APP-GW-GLR-045-NS, Revision 1  
"Nuclear Island: Evaluation of Critical Sections"  
Technical Report Number 57

**TITLE: Nuclear Island: Evaluation of Critical Sections**

## **Nuclear Island: Evaluation of Critical Sections**

The AP1000 design has been certified for application at a hard rock site. Seismic analyses of the AP1000 at soil sites are described in Reference 3. The design of Nuclear Island structures was reconciled, and if needed, updated to address the seismic analyses results of Reference 3.

Figure 3H.5-2 (Sheet 1)

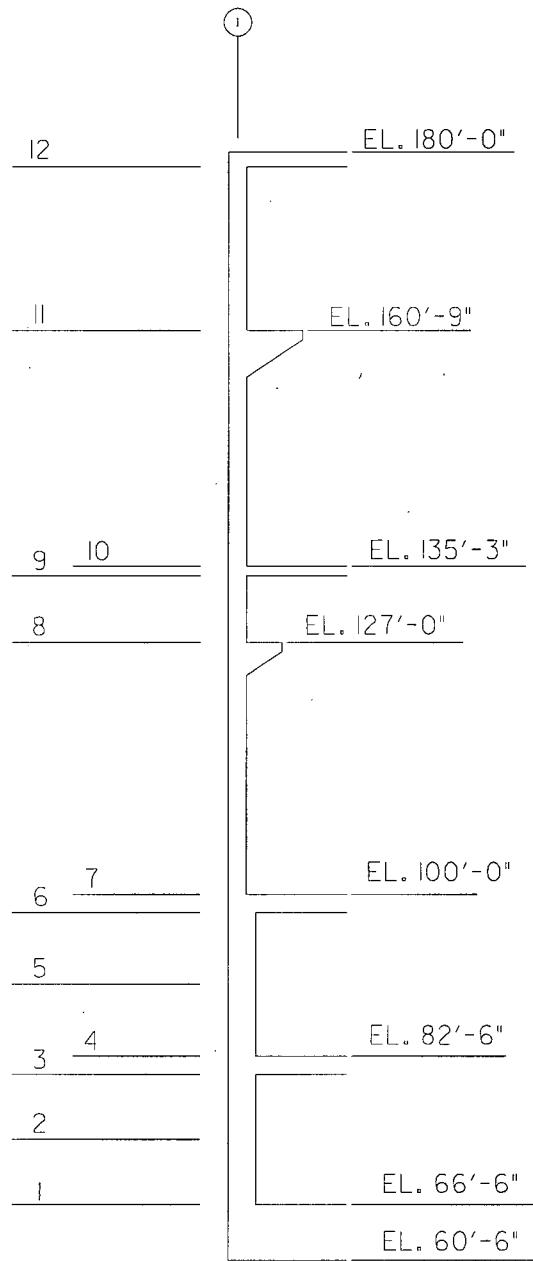
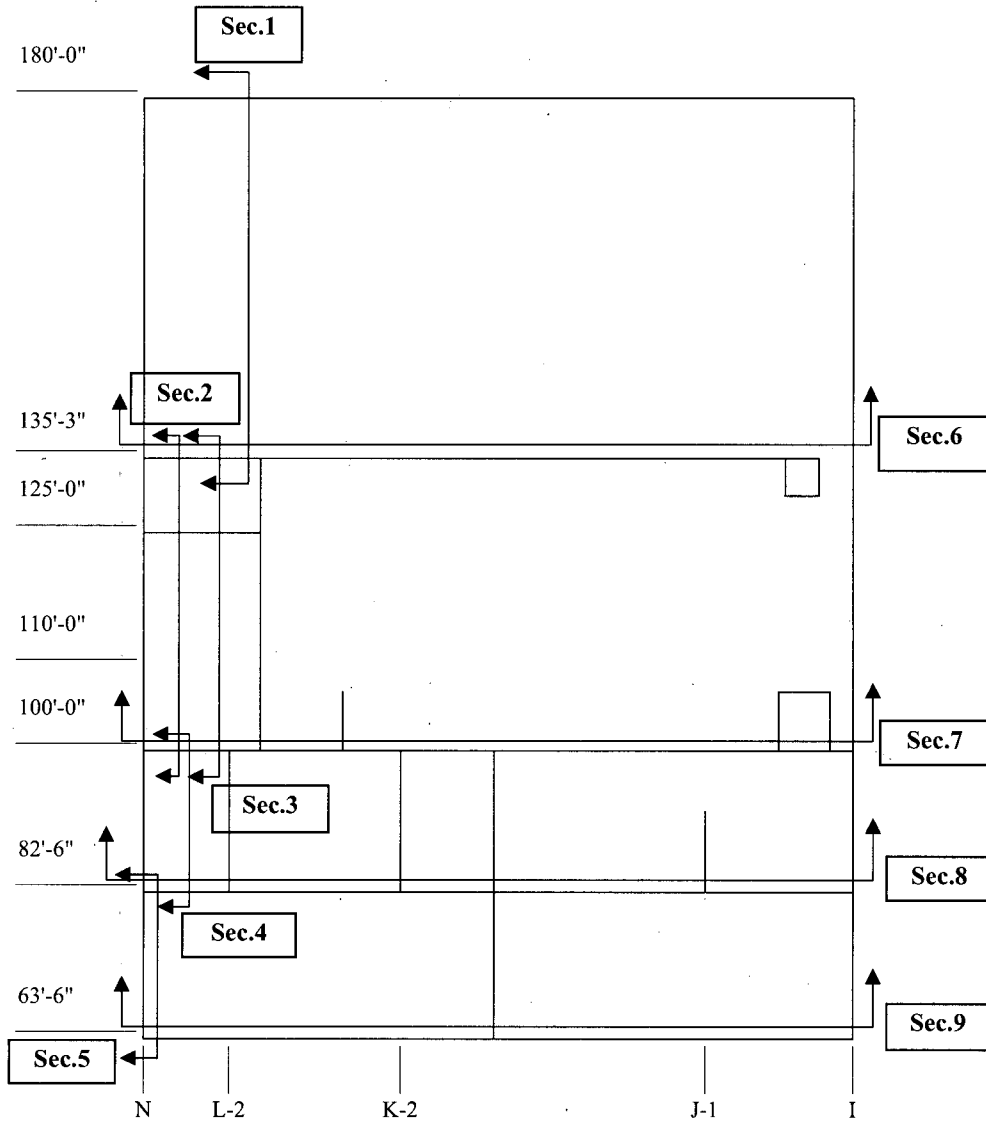
**Figure to be deleted**

**Figure to be inserted**

Figure 3H.5-3

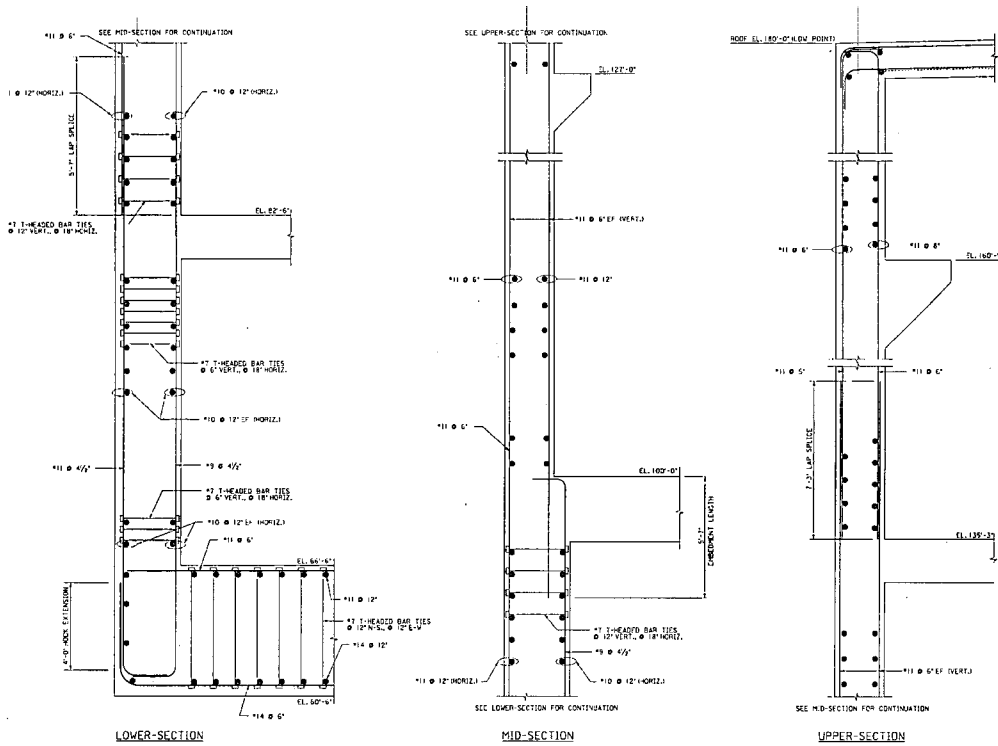
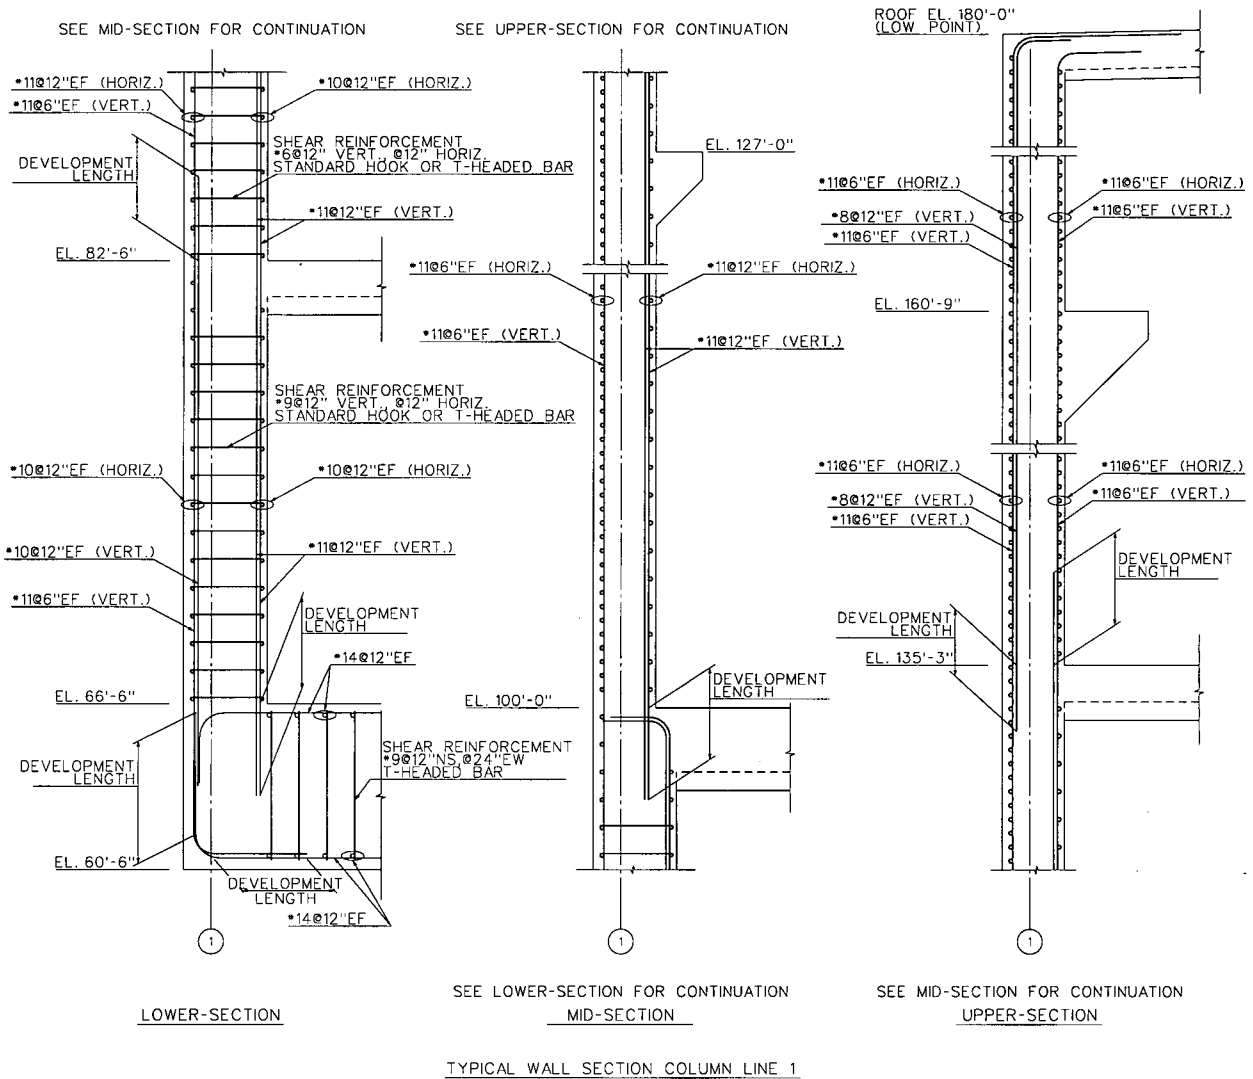
**Figure to be deleted**

**Figure to be inserted**

Figure 3H.5-2 (Sheet 2)

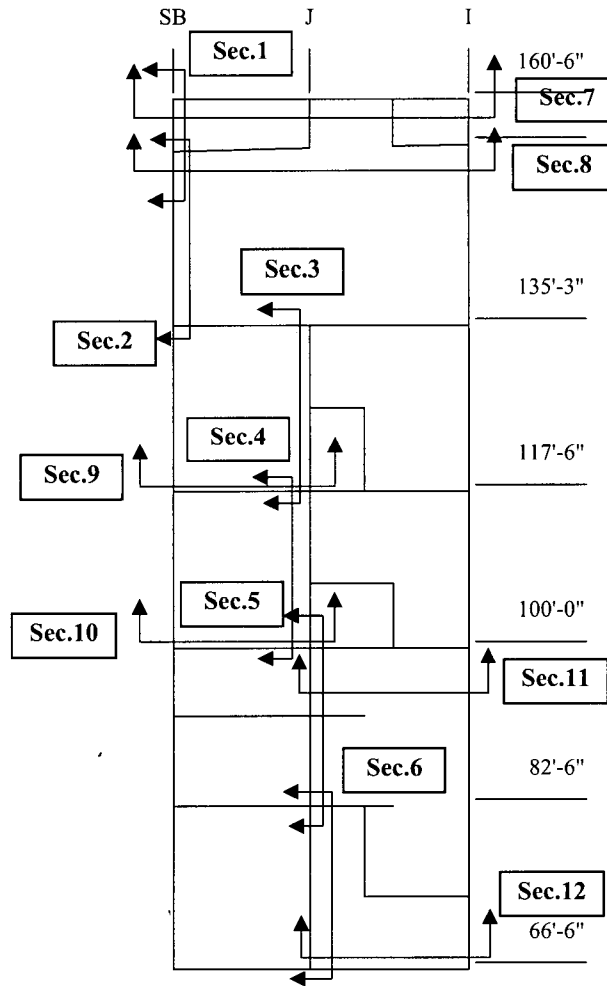
**Figure to be inserted**

Figure 3H.5-4

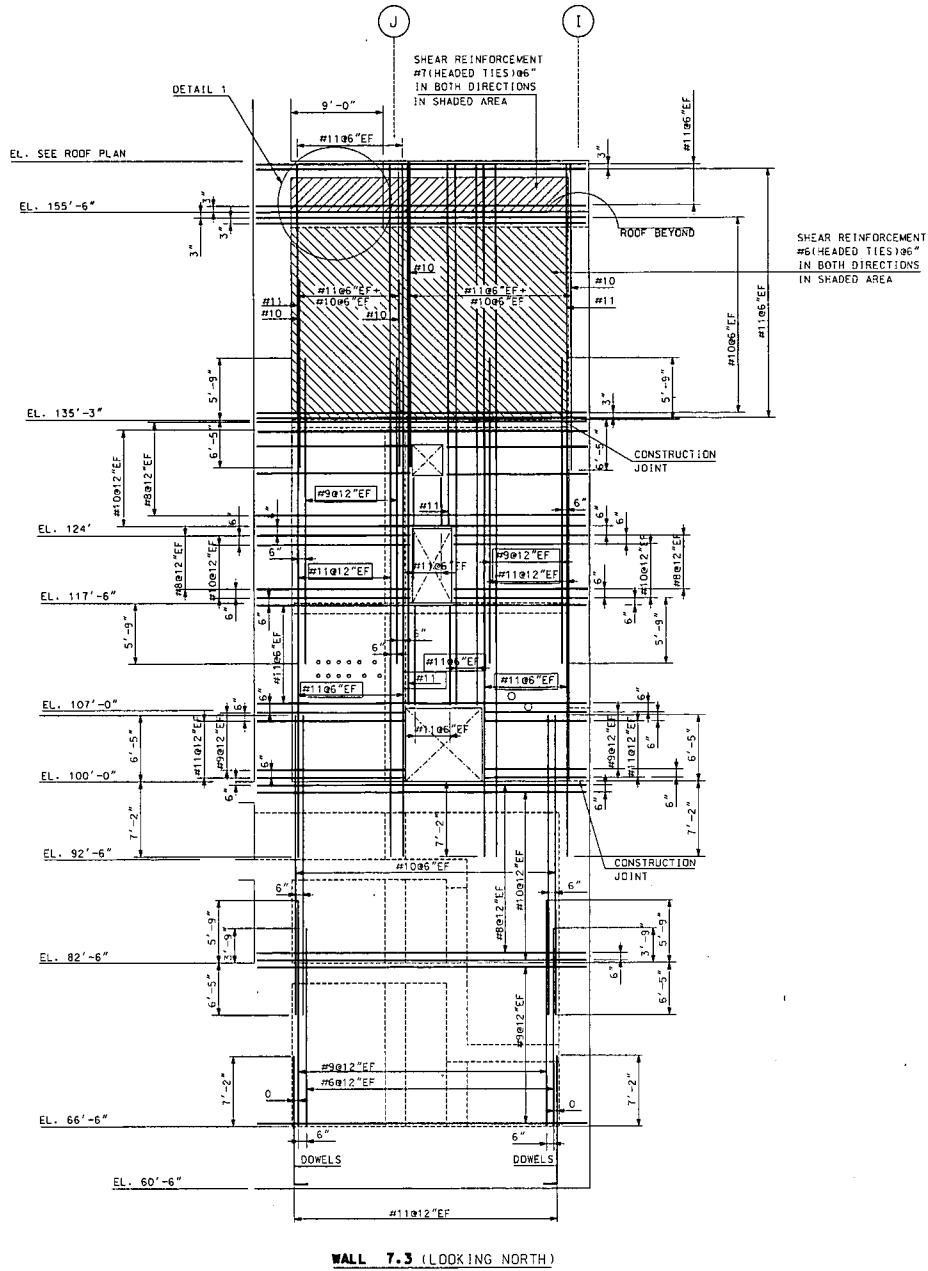
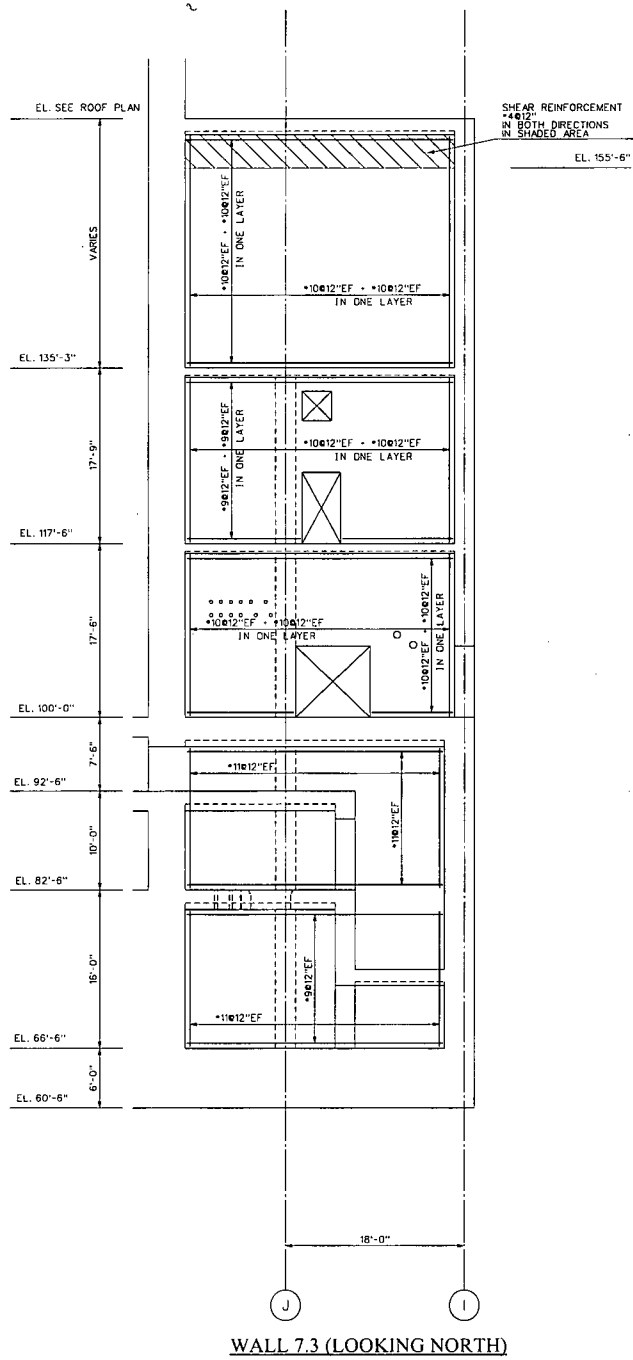
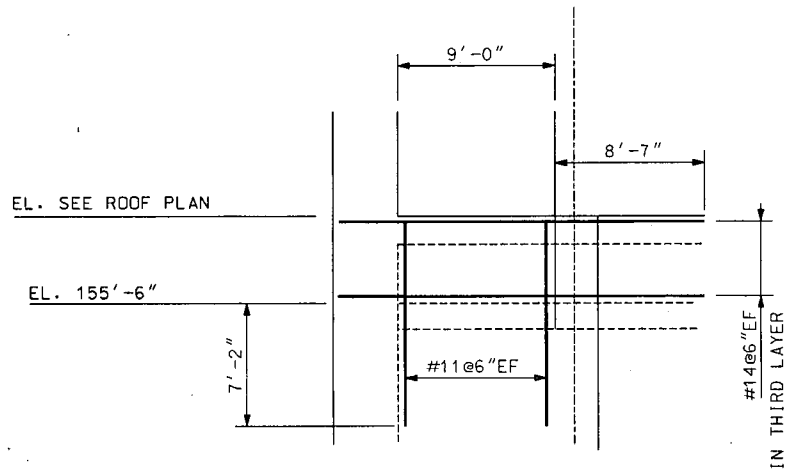
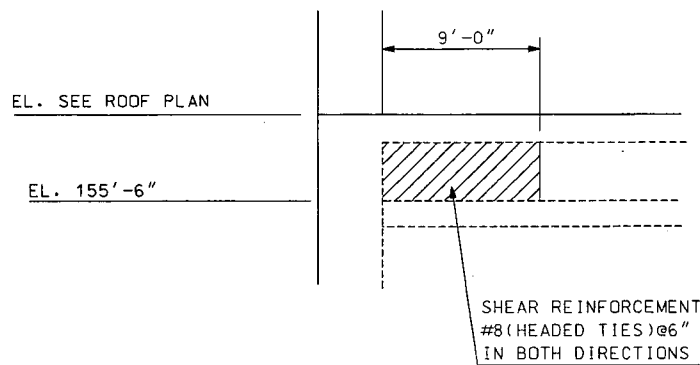
**Figure to be deleted**

**Figure to be inserted**

**Figure to be deleted**

Figure 3H.5-2 (sheet 3)

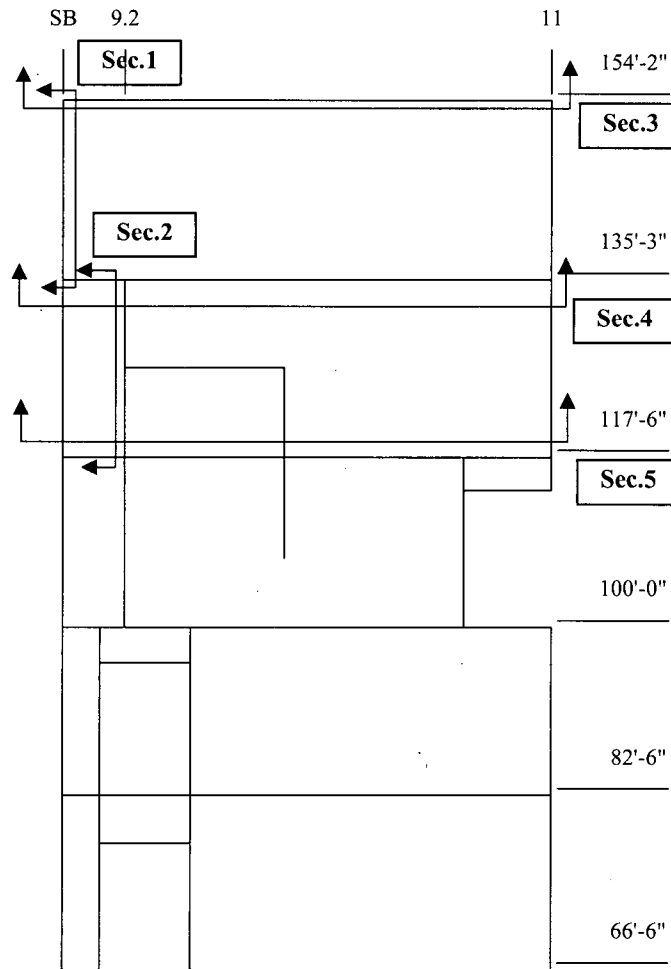
**Figure to be inserted**

Figure 3H.5-12

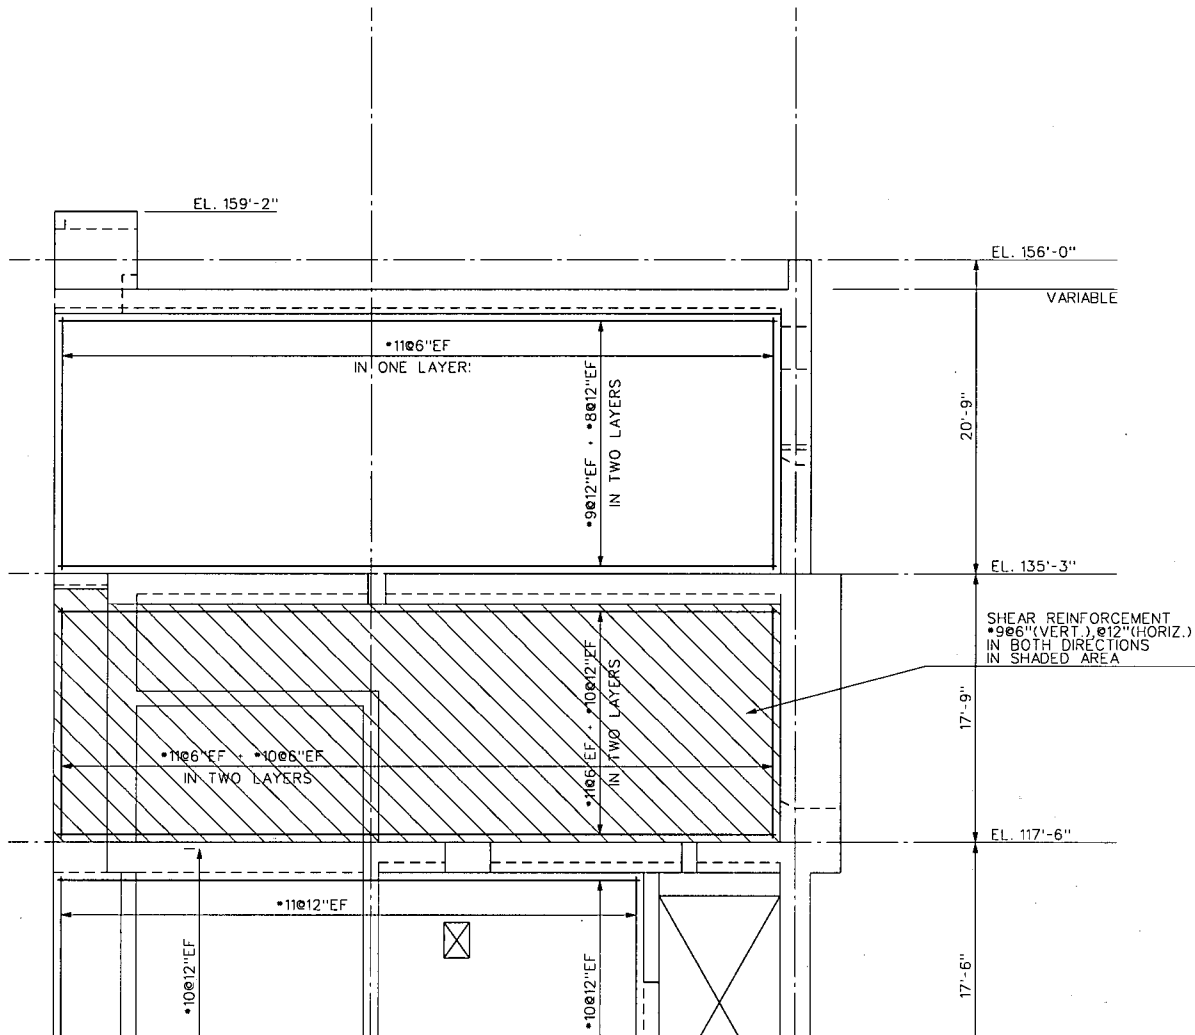
**Figure to be inserted**

Figure 3H.5-5 (Sheet 1 of 3)

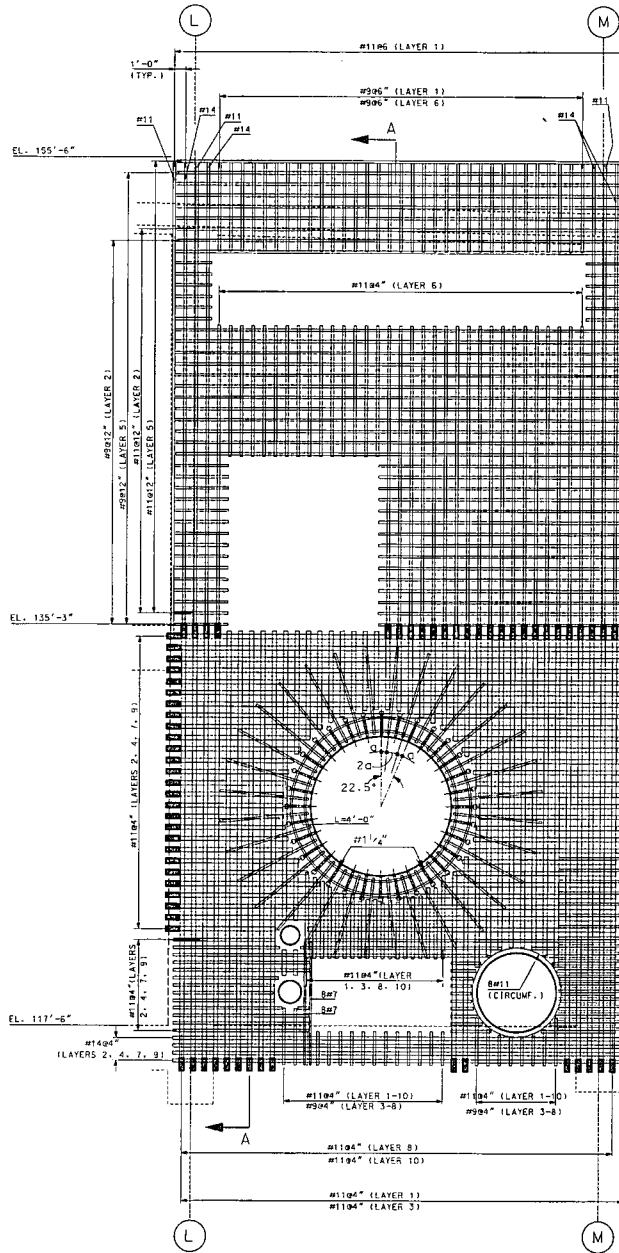
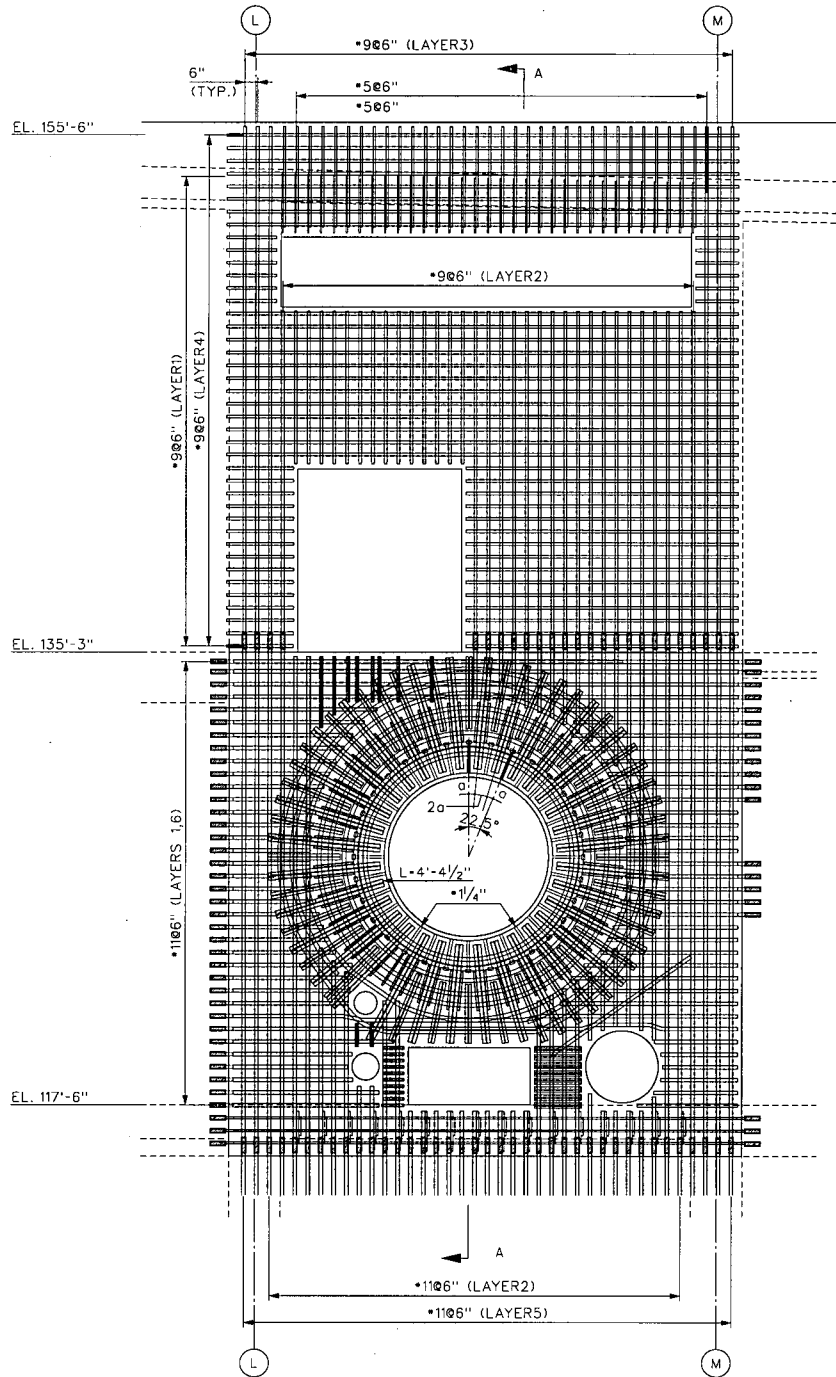
**Figure to be deleted**

**Figure to be inserted**
